Notice of Modification

Section 75W of the *Environmental Planning and Assessment Act 1979*

Project Approval:	Granted by the Minister for Planning on 20 July 2007.
In respect of:	Project application 05_0120 made by Amcor Packaging (Australia) Pty Ltd, in relation to 1891 Botany Road, Matraville in the Randwick local government area.
For the following:	Changes to site layout and subdivision of land at the Amcor Paper Mill.

Figure 3: McCauley Street Upgrade

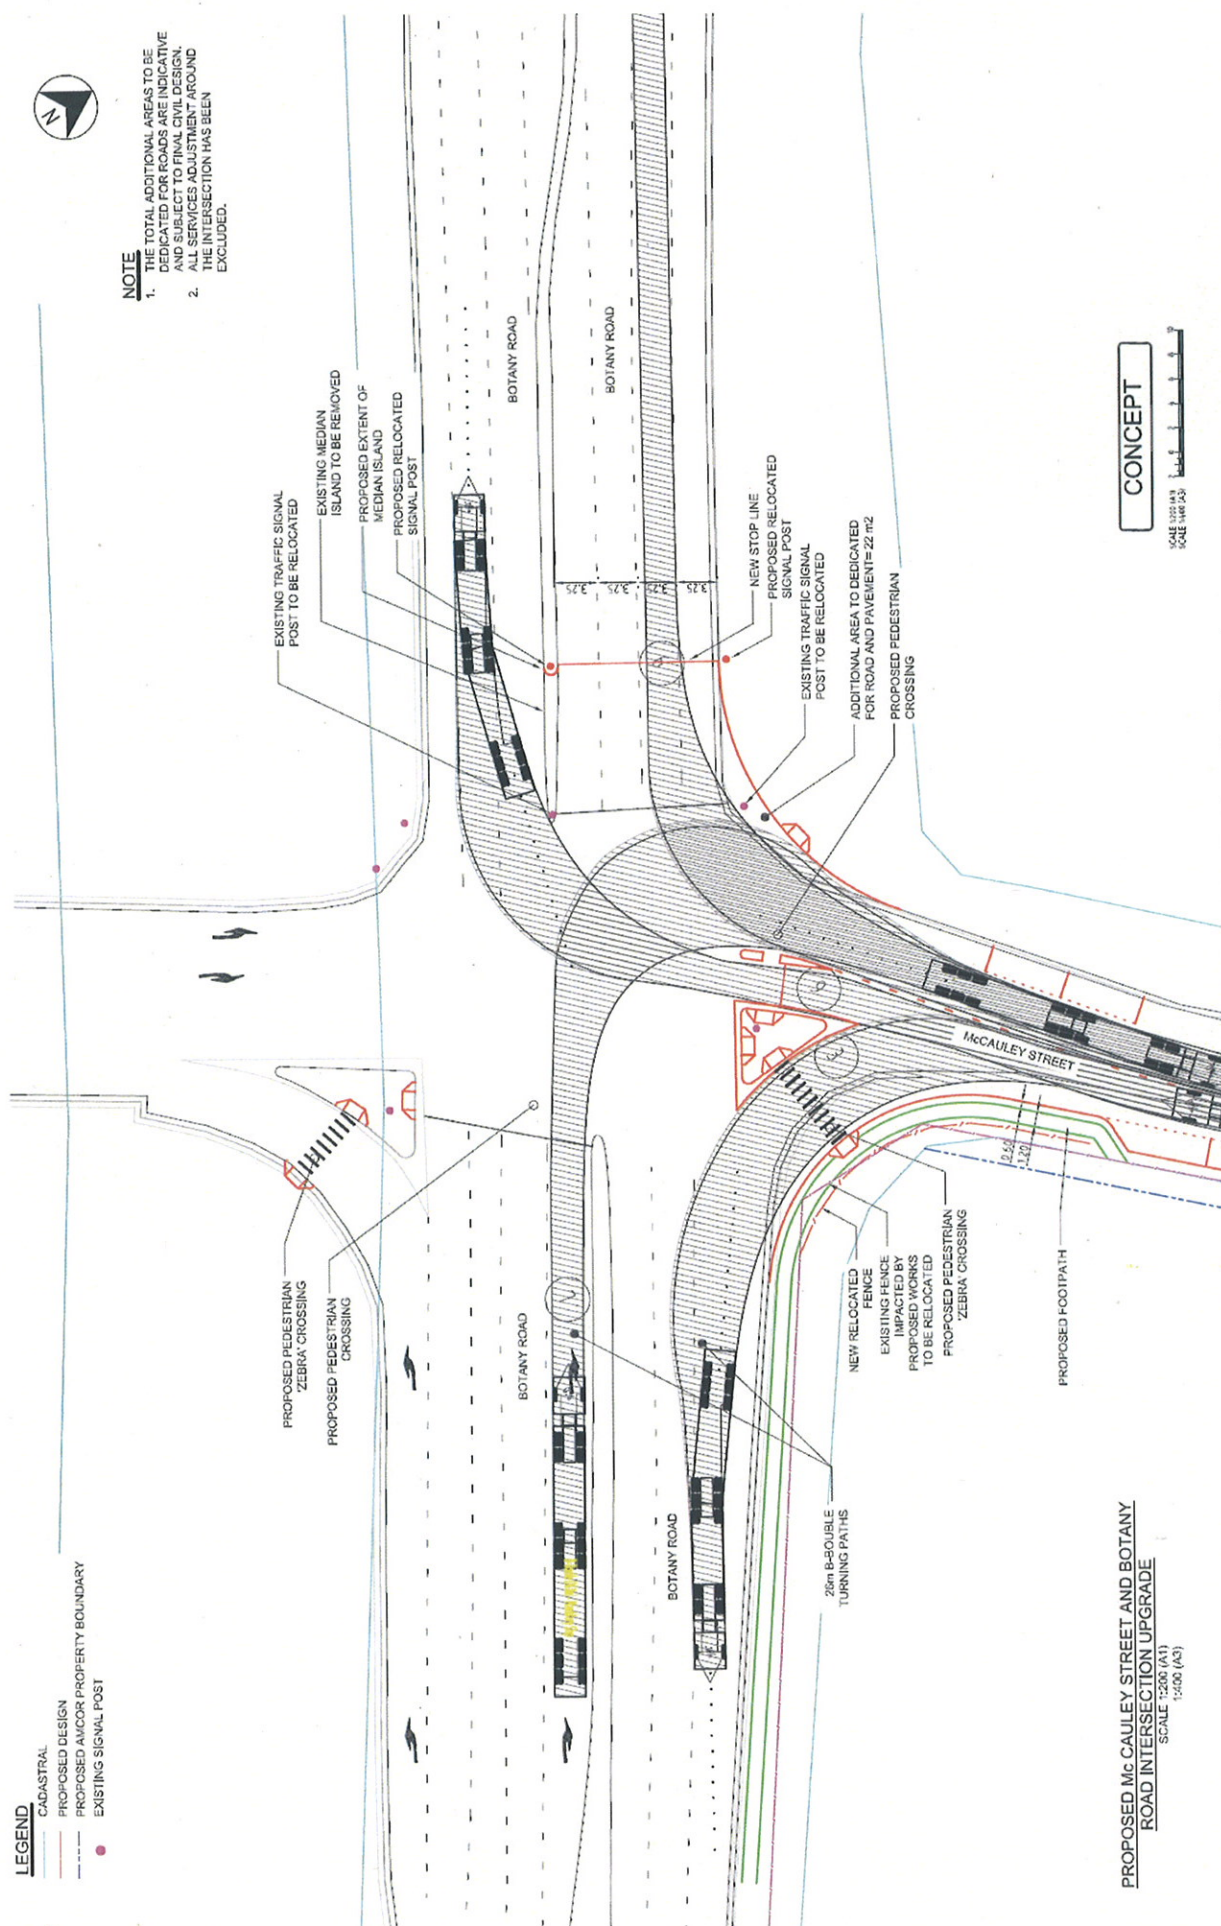
12. Replacing existing Figure 1 with a new Site Layout Plan.
13. Inserting new Figure 3: McCauley Street Upgrade.
14. Inserting new Figure 4: McCauley Street and Botany Road Intersection Upgrade.
15. Inserting new Figure 5: Subdivision Plan.

- 20A. Prior to the commencement of operations of the project, the Proponent shall upgrade McCauley Street between Botany Road and Raymond Avenue, to the satisfaction of the Director-General. The Proponent shall:
 - a) submit detailed design of the road upgrade works to Council for approval;
 - b) fund the full cost of the upgrade works;
 - c) dedicate a strip of land adjacent to McCauley Street, up to 2 metres wide, to Council as a public road, excluding the heritage wall which is to be retained on Amcor owned land;
 - d) consult Council on design of the shared access on McCauley Street opposite Raymond Avenue;
 - e) consult Council on the most appropriate traffic management measures for limiting heavy vehicle movements north of Raymond Avenue; and
 - f) apply to the RTA for the southbound section of McCauley Street to be designated as a B-double route prior to operation.
